ADDENDUM #1

TO CONTRACT DOCUMENTS ENTITLED: Project #CP241341 Various Locations – FY24 Summer Paving Project – Asphalt

CONSULTANT: MECO Engineering Co., Inc.
2701 Industrial Drive, Jefferson City, MO 65109
573-893-5558
Project Number 473-070

ADA PARKING SIGN

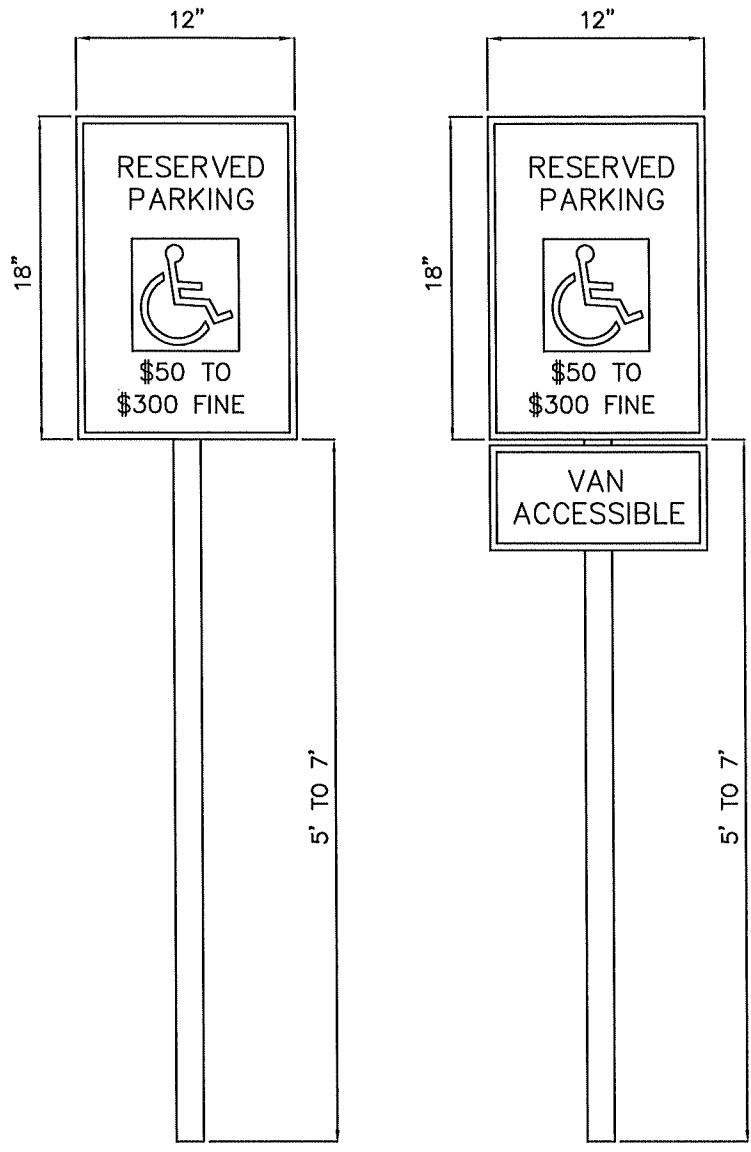
a) Add the attached new ADA sign detail to the sheet

SG7B ADA STRIPING LAYOUT

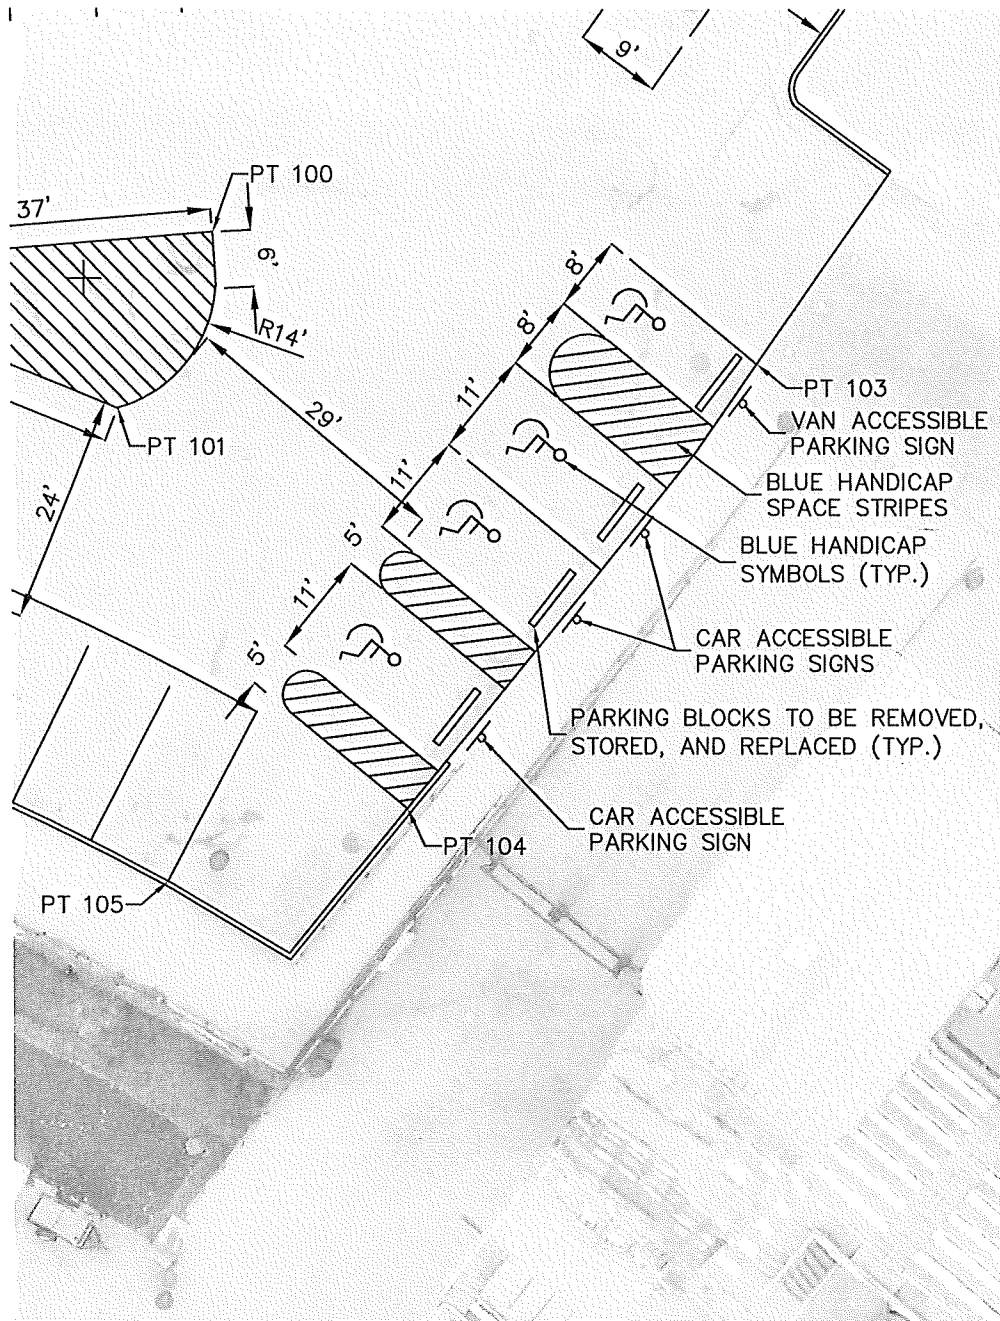
b) Remove the ADA striping shown on the plan sheet and replace it with the ADA striping detail attached.

ALTERNATE BID NO. 1 SG4/M SIGN LOCATION AND TRAFFIC CONTROL			
SCALE	DRAWING NAME	PROJECT NUMBER	SHEET NO.
	TrafControlSG4M-Adden	CP241341 473-070	15

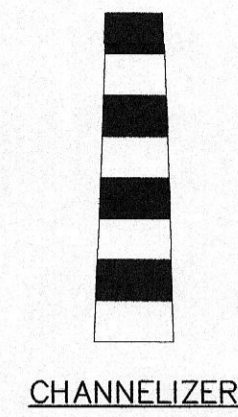
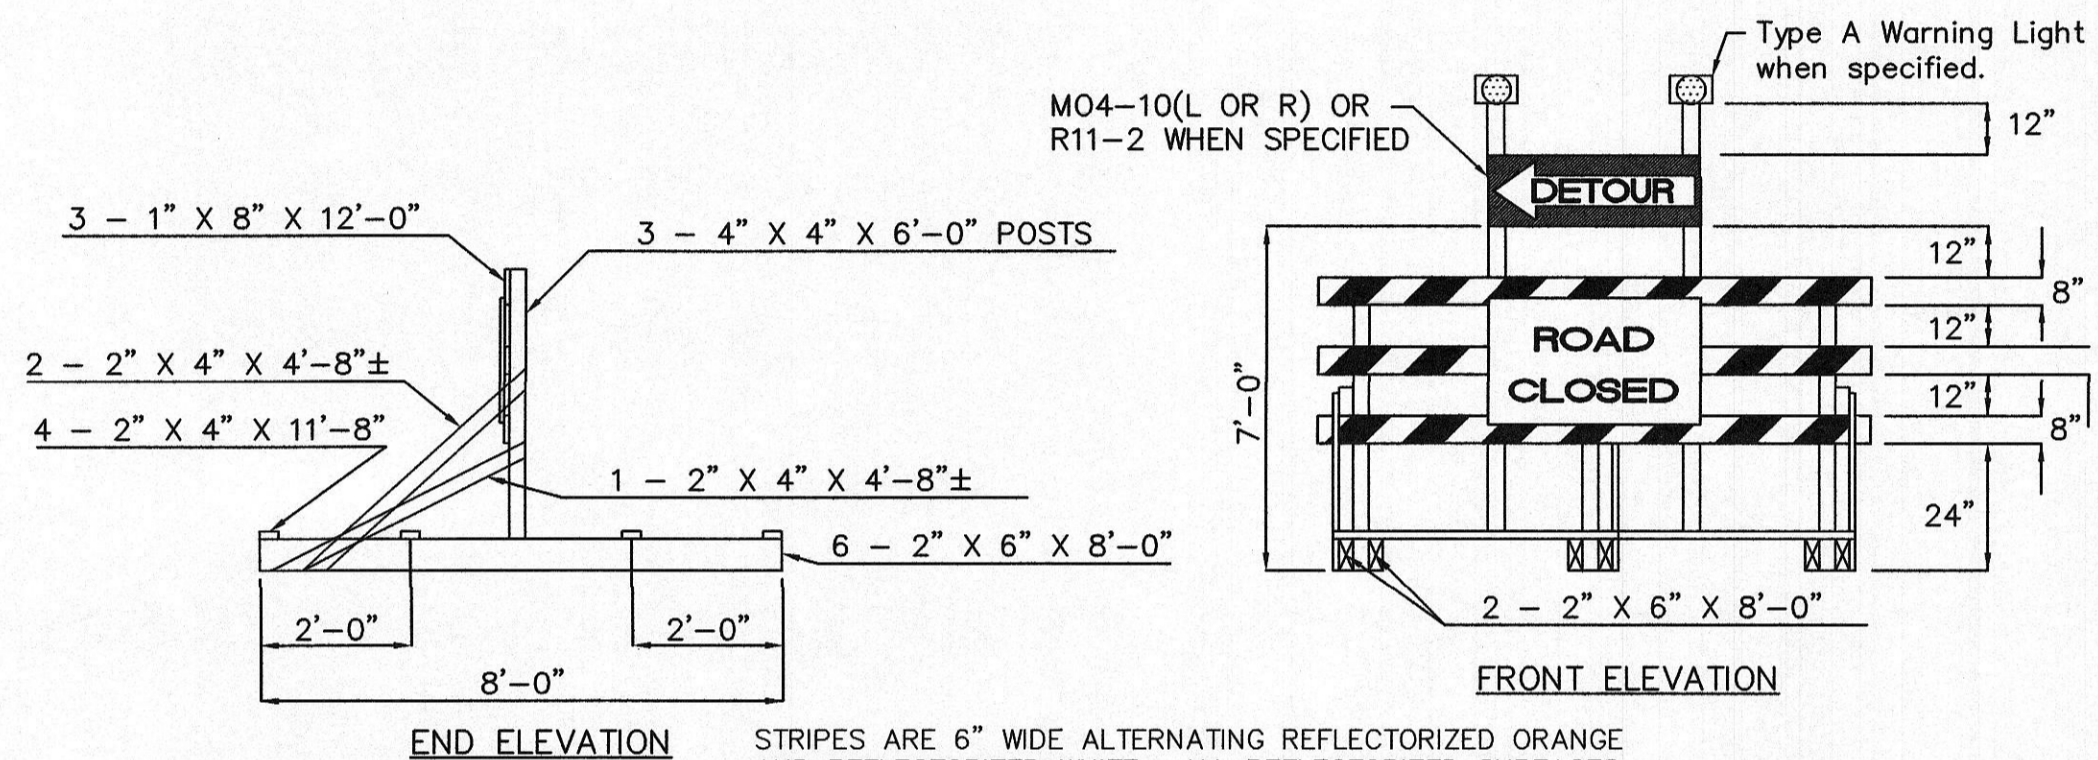
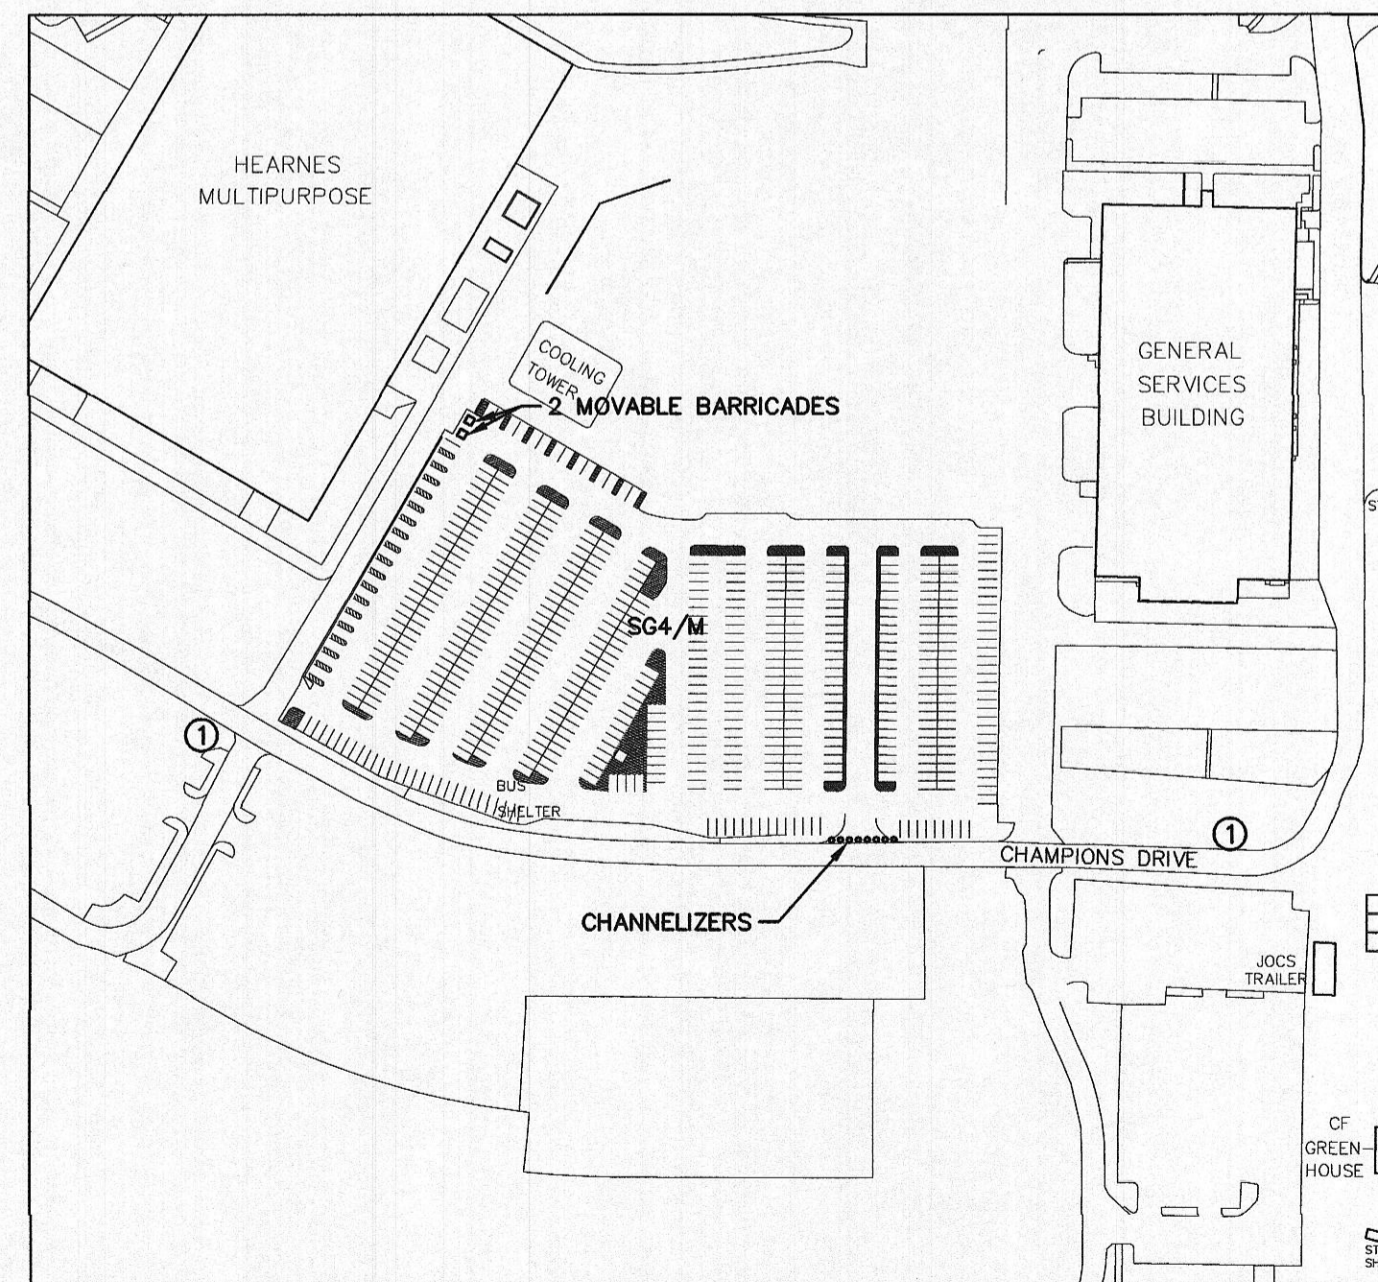
- 4) Add Section 1.F Index of Drawings: The index of sheets has additional sheets representing the Alternate Bid: Sheet No. 15: Alternate Bid No. 1, SG4/M Sign Location and Traffic Control; Sheet No. 16 and 17: Alternate Bid No. 1, SG4/M Repair Plan; and Sheet No. 18 and 19: Alternate Bid No. 1, SG4/M Striping Plan

- 1) Sheet No. 1 Cover Sheet: Change the Drawing Index to include:
Sheet 15: Alternate Bid No. 1, SG4/M Sign Location and Traffic Control
Sheet 16 and 17: Alternate Bid No. 1, SG4/M Repair Plan
Sheet 18-19: Alternate Bid No. 1, SG4/M Striping Plan
- 2) Add Sheets 15-19, marked Alternate Bid No. 1, to the Plan Set.
- 3) Sheet No. 3 Sign Location and Traffic Control, Detail SG7/A and SG7/B remove the two movable barricades indicated on the drive to the tunnel.
